# **Seismic Evaluation of the U1a Complex at the Nevada Test Site**

## ***Interim Report*** **SM98-24**

**November 4, 1998**

**Figure 15: The trailer wheels may be restrained to limit seismic motion of the trailer.**

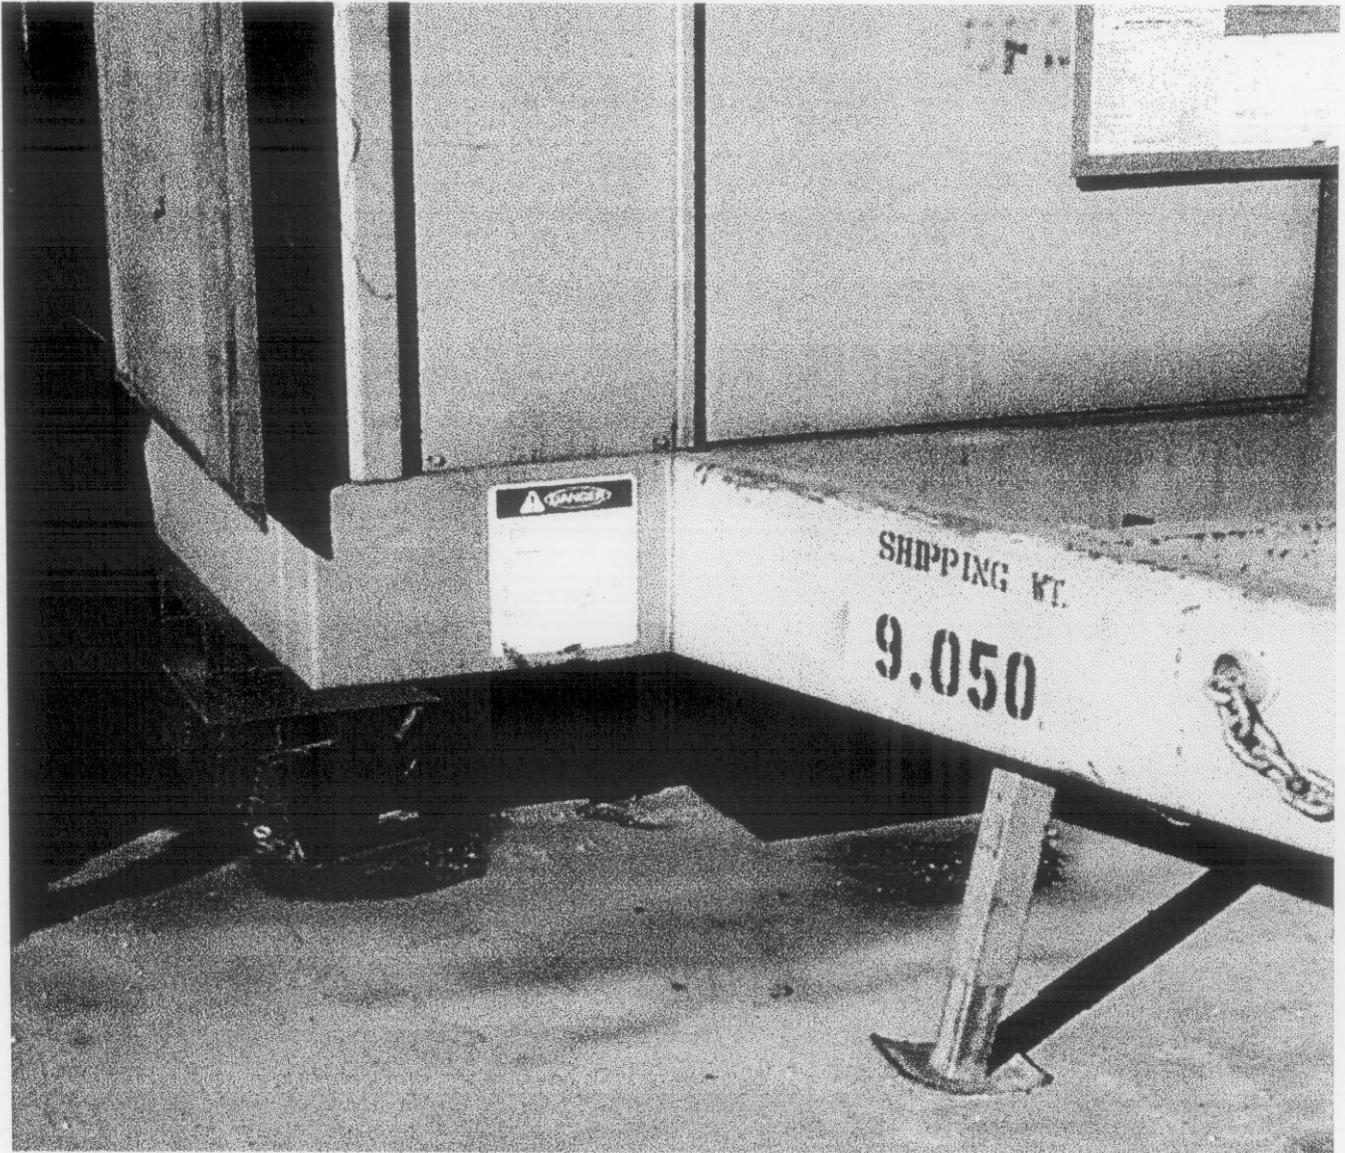
Some trailers are supported on wood cribs up to several feet above ground as shown in Figure 14. It is not clear that the wood cribs could remain intact during an earthquake; therefore, recommendation was made to evaluate the stability of the cribs. Some trailers are supported on wheels on one end and on small tripods on the other end as shown in Figure 15. It is possible that the wheels might experience significant movement that the tripods could overturn. It was recommended to limit the wheel rolling by shimming with blocks.

**Figure 16: Large cable bundles run over and across the emergency egress of the U1g refuge area.**

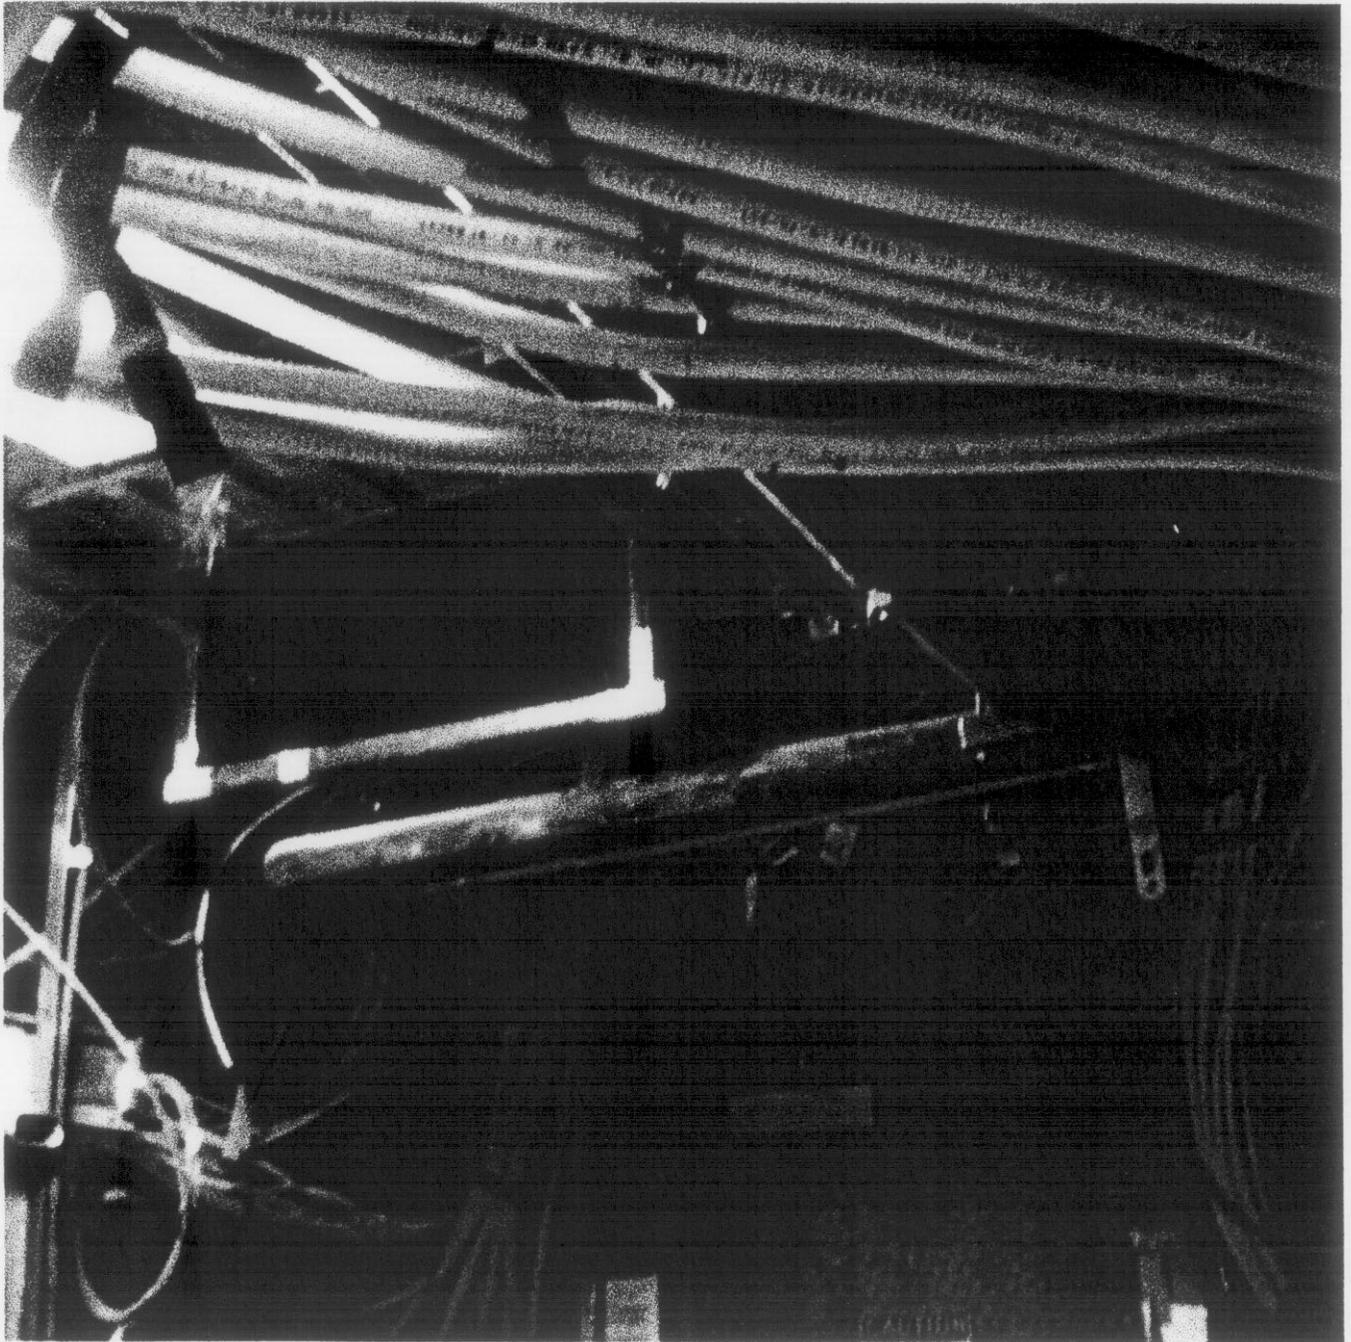
The U1g refuge area is located in the Vent Drift, including the 15-psi bulkhead area and the U1g User Area. Many heavy cables are routed over the U1g refuge area egress as shown in Figure 16. The cable support and anchorage should be re-evaluated to prevent the cables from falling down and blocking the egress in case of an earthquake.

Figure 17: The vent line is supported on different weights of cables and wires.

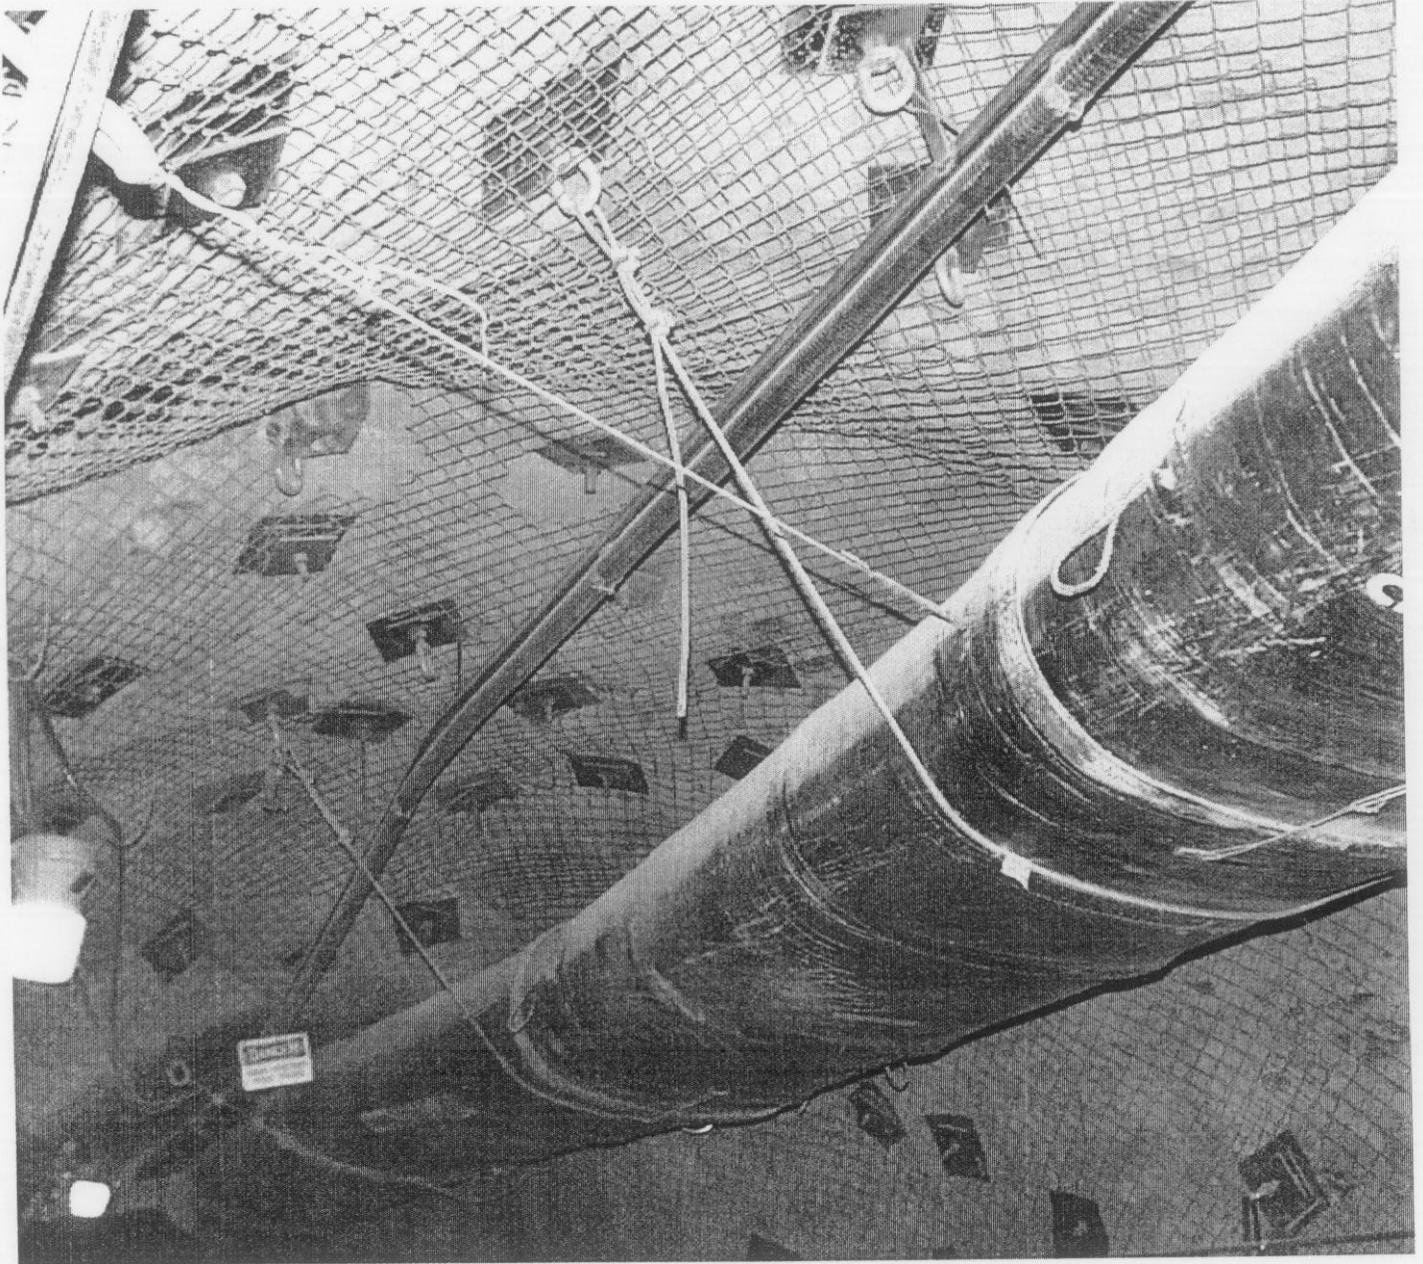
Figure 17 shows a typical redundant anchorage for the vent line. One cable supports from the bottom of the duct while another cable from the side. The weight of the cable is not consistent throughout the entire length of the vent line. Figure 18 is taken at an intersection of the vent line with larger duct sections. The cable is light weight and loosely wraps around the duct. *As shown in Table 8, recommendations for air line anchorage were made in various locations in the tunnel.*

**Figure 19:** Free-standing cabinets are hazardous to worker safety in a refuge area during earthquake.

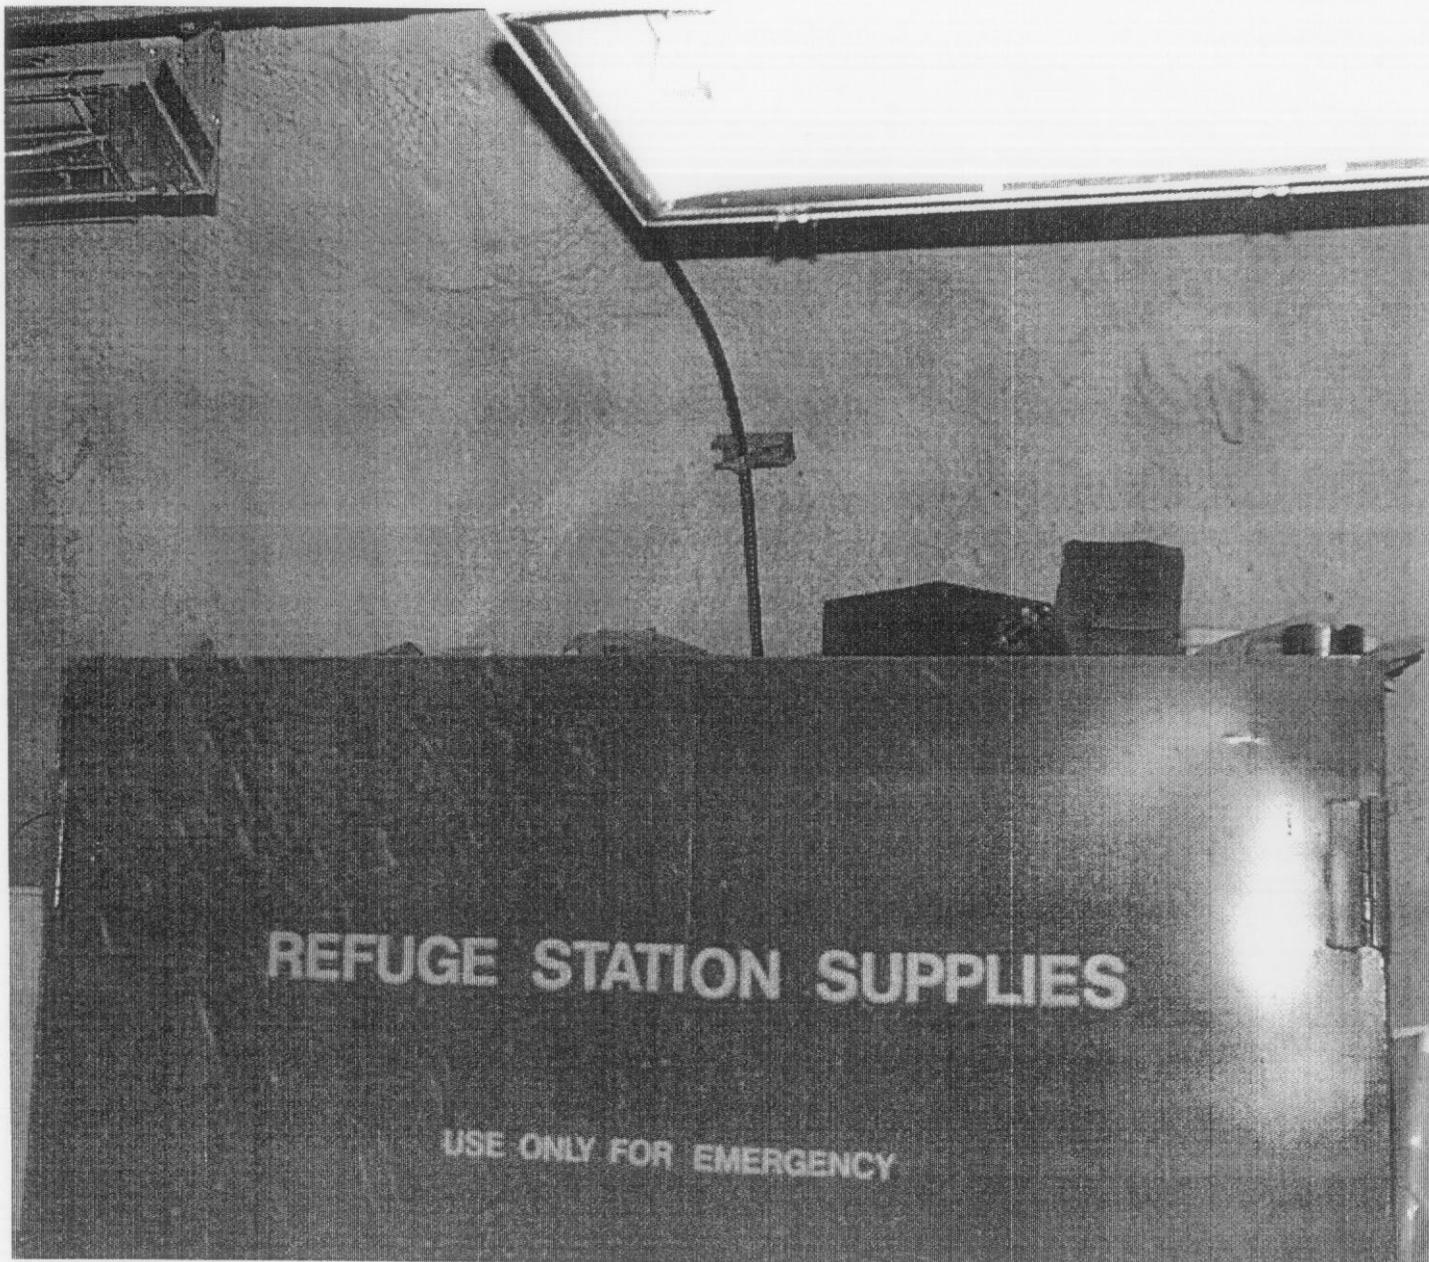
In the refuge area, refuge station supplies are kept in tall cabinets. Figure 19 shows a free-standing tall cabinet marked for emergency use. Recommendation was made to properly anchor the refuge station supply cabinet to the wall. In Figure 20, two tall cabinets are tied to the wall with loose cables. The interaction between two cabinets and the warning light is a concern to the seismic safety of the workers who take refuge in that area.

**Figure 23: Free-standing switches and diesel generator connected with rigid conduit.**

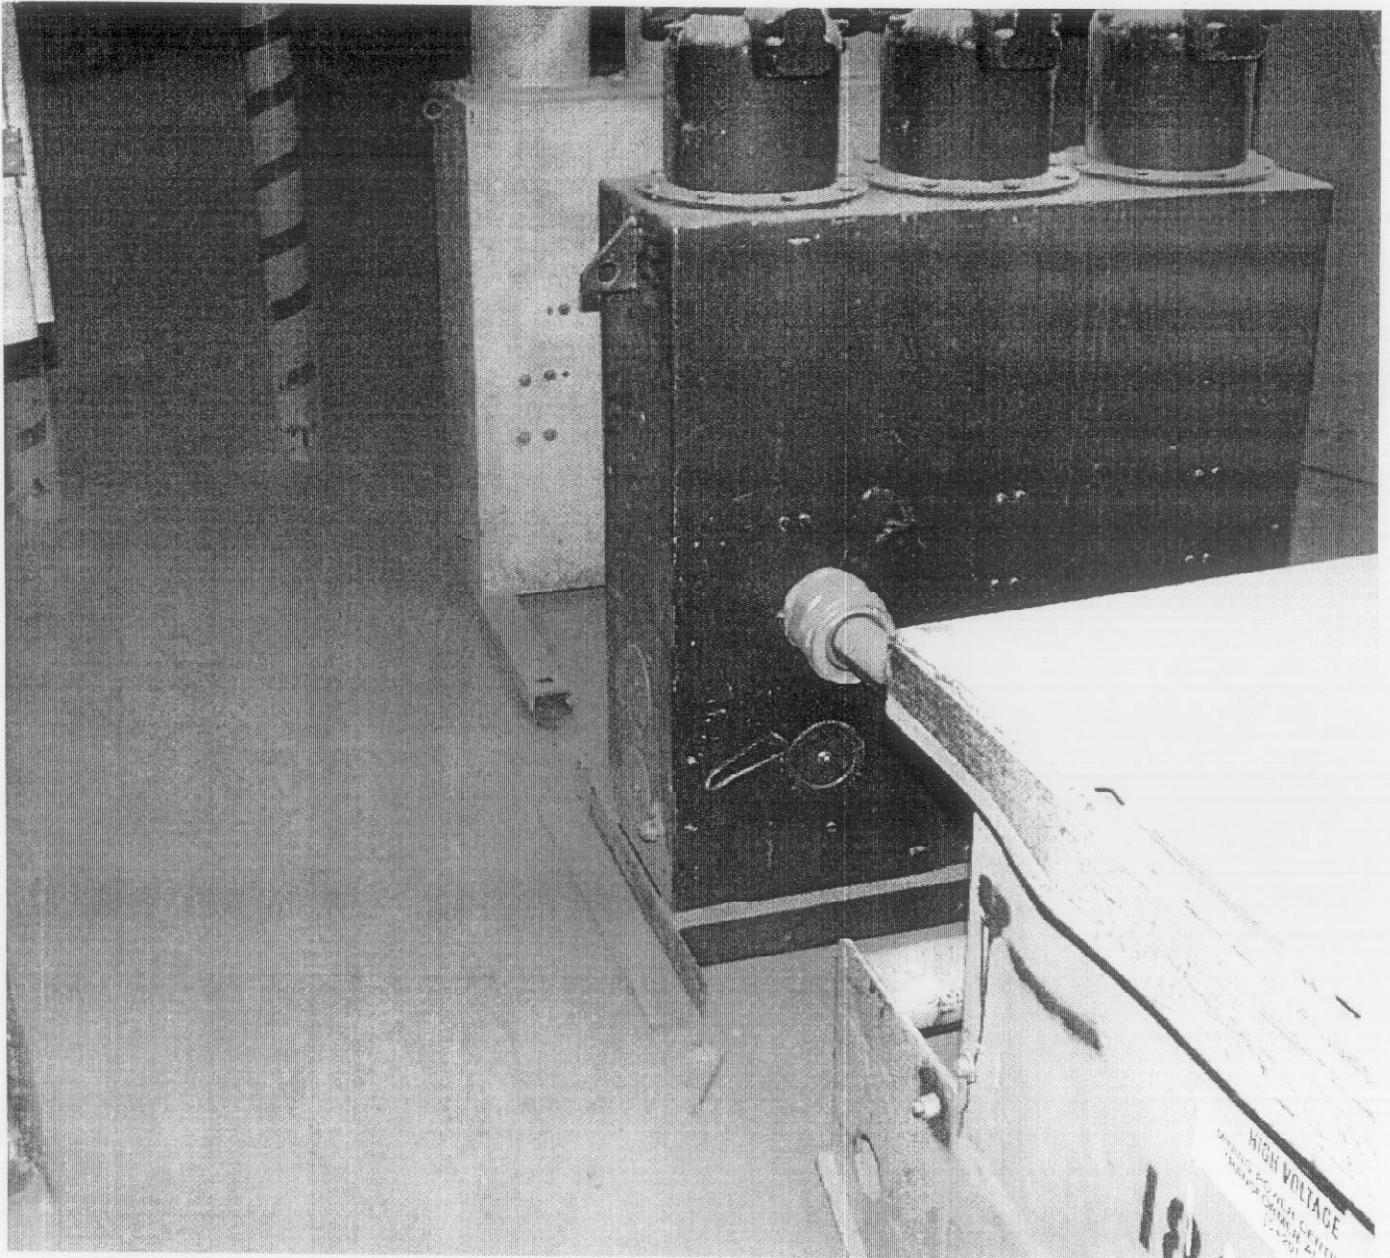
Figure 23 shows a typical, rigid conduit connection between the switches and the diesel generator. Both the switches stand and generator are free-standing and can move out-of-phase during earthquake. The diesel generator might be heavy enough not to have uplifting seismic forces while the switches do. Differential seismic displacement may be inevitably causing damage to the high voltage cables.

**Figure 24:** Groups of the instrumentation cabinets rest on timber blocks in the DX-12 Alcove.

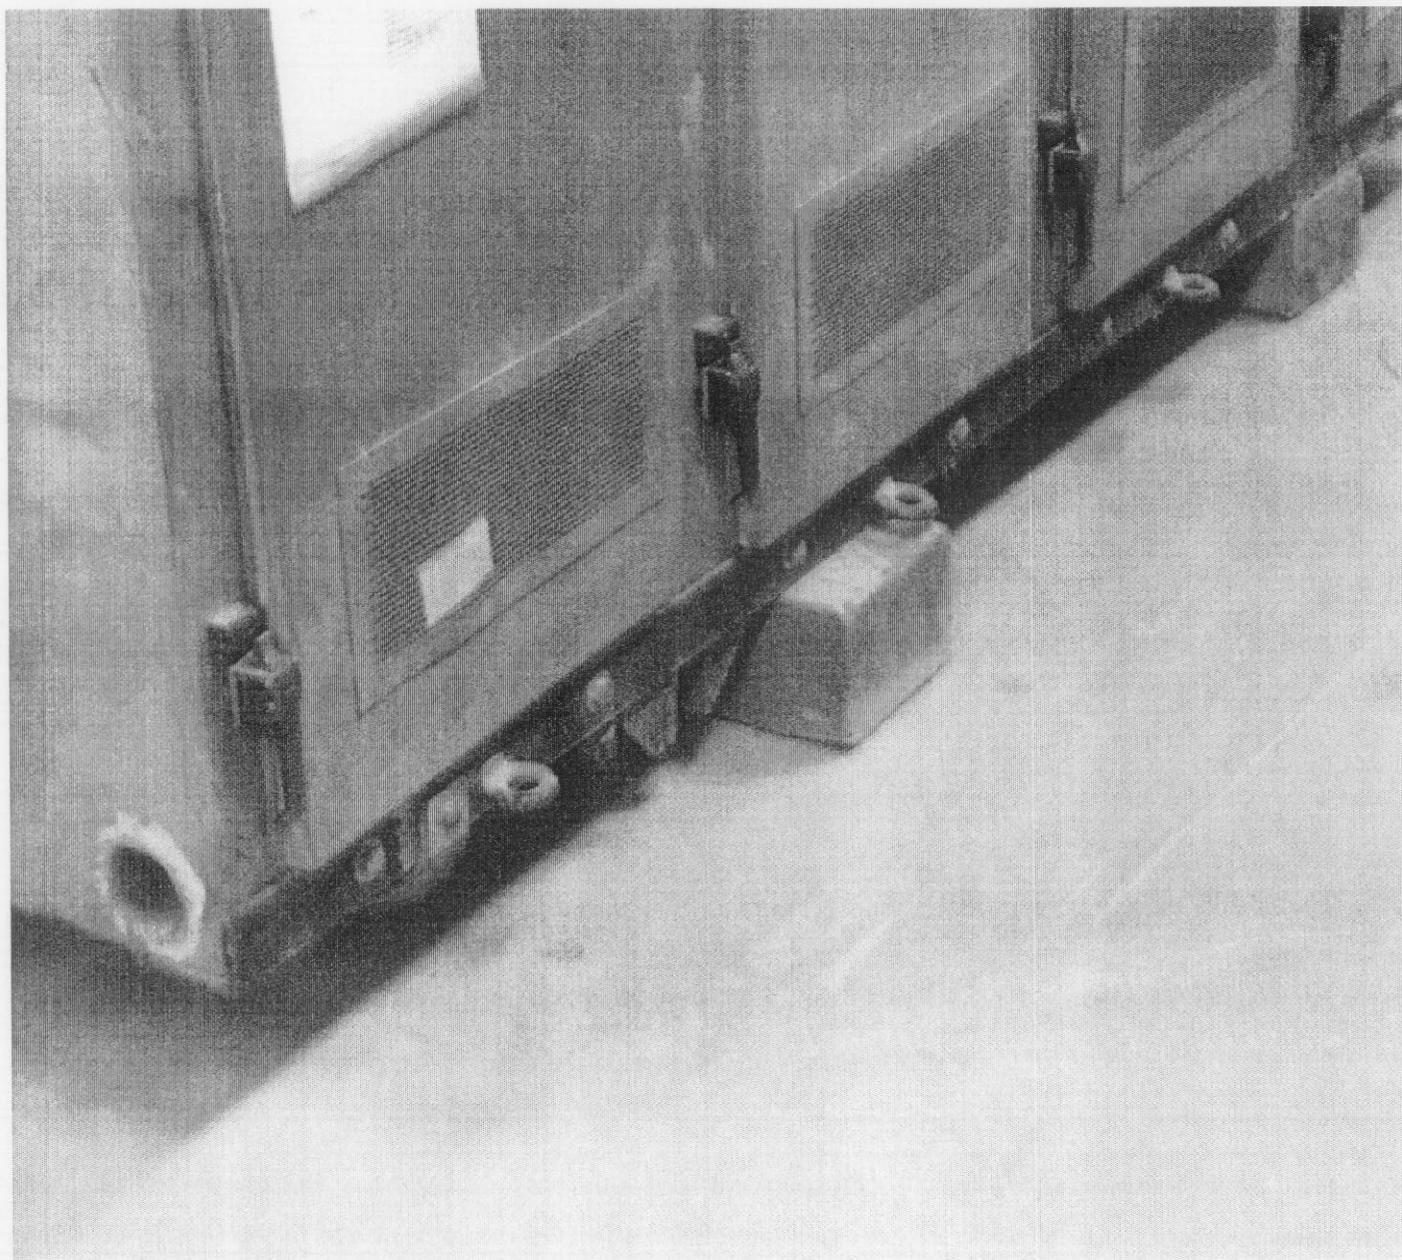
Figures 24 and 25 were taken in the DX-12 Alcove and U1g User Alcove, respectively. In these two alcoves, groups of instrumentation cabinets rest on timber blocks. The groups of cabinets might not overturn due its large foot print and restraint provided from the cables connection at the

top of the cabinets. However, evaluation is recommended to determine the stability of the cabinet group to ensure that the cable will not be separated from the instruments.
